CITY OF ALBUQUERQUE

Hydrology Section Planning Department Brennon Williams, Acting Director

RE: Mister Car Wash – 201 98th St NW

ESC Plan Engineers Stamp Date: 7/23/2019 K08E004

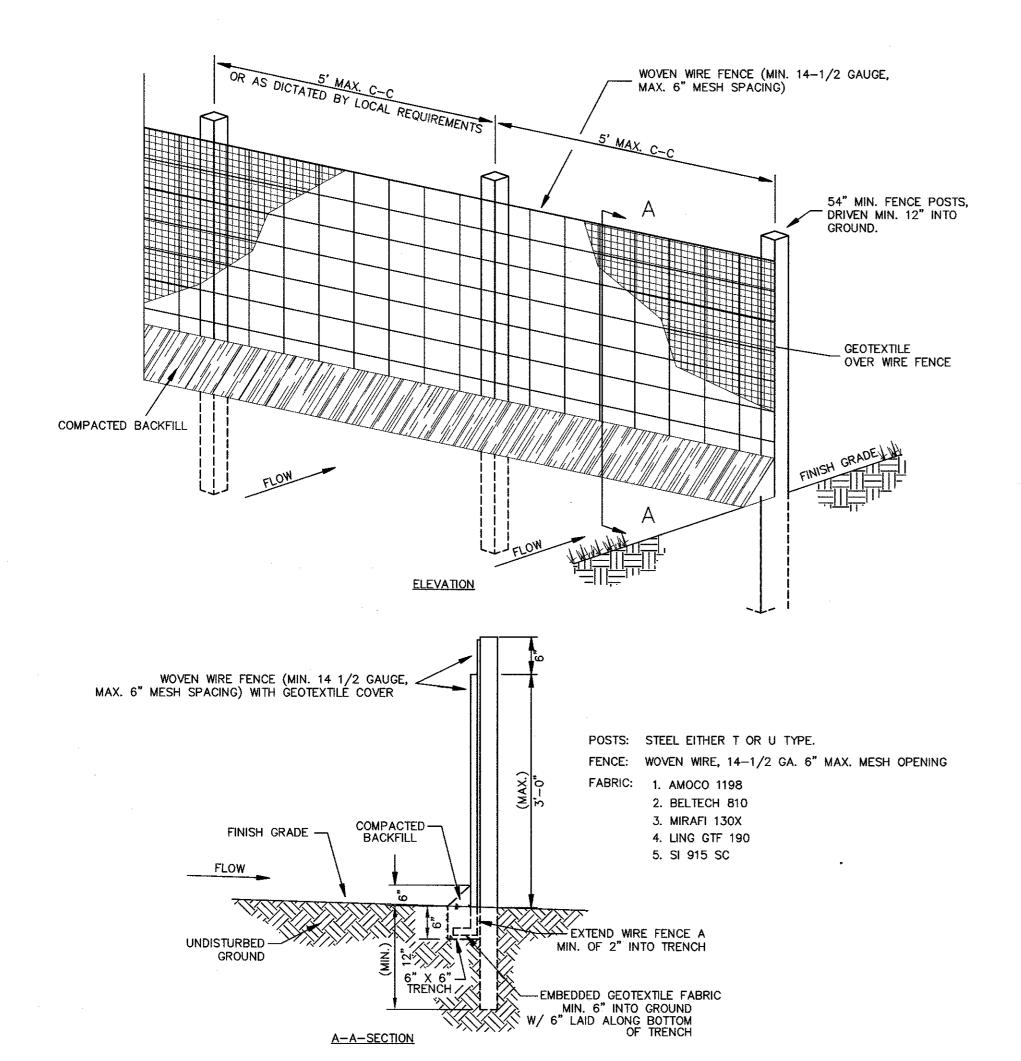
- 1. Clearly show the limits of disturbance including the area to be disturbed by the Work Order.
- 2. Clearly add a perimeter control around the low side of the project like Silt Fence
- 3. Clearly add inlet protection at the pond outlets and inlets in the public ROW.
